Release 1: Original release

HUBODOMETER SUPPORT MODIFICATION

Prevost vehicles

Figure 3

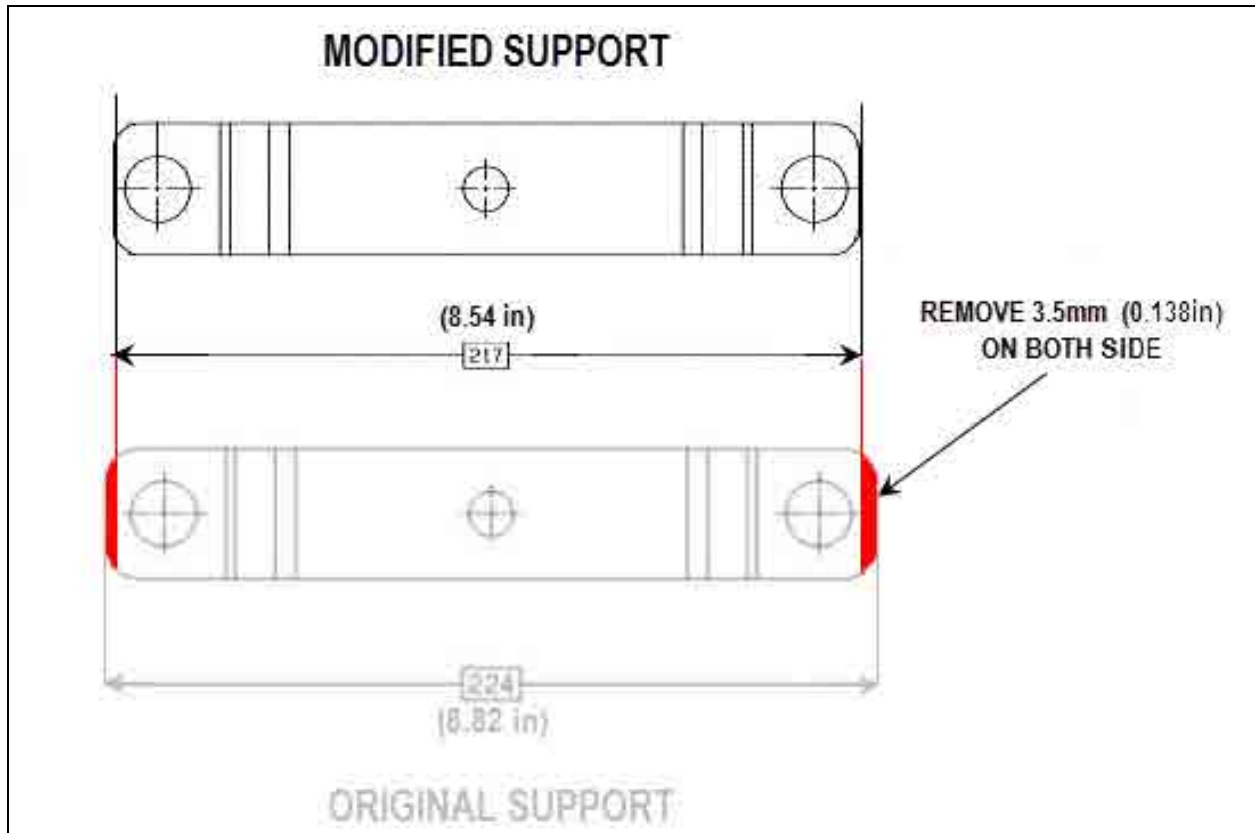
- 3) Using a bench grinder, remove 3.5mm from both ends of the hubodometer support. Refer to the illustrations below as a template and for the final measurement of the modified support (Figure 3).

Figure 4

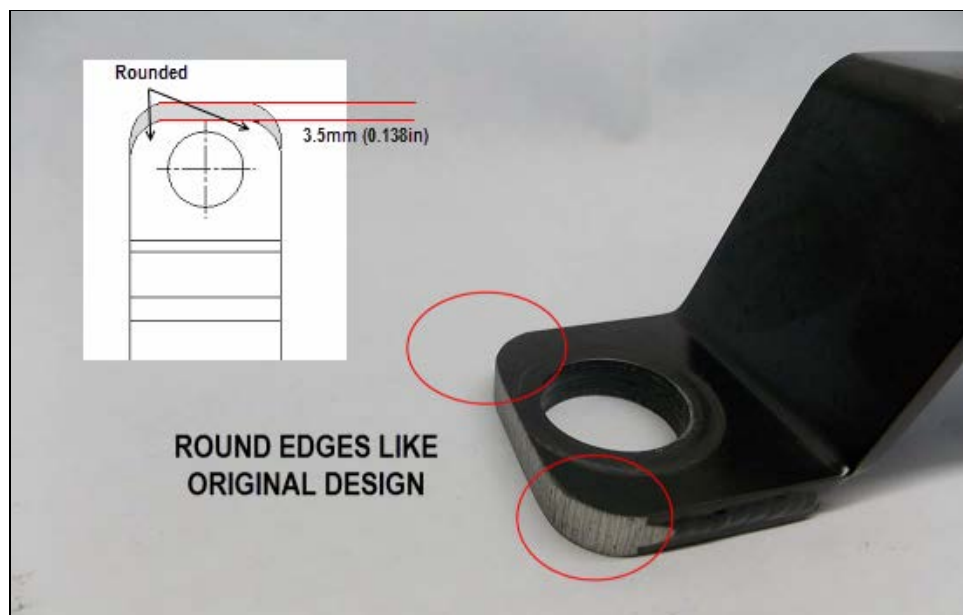
- 4) Grind the edges to keep the as much as possible the original “rounded” shape as seen in the illustrations below (Figure 4).
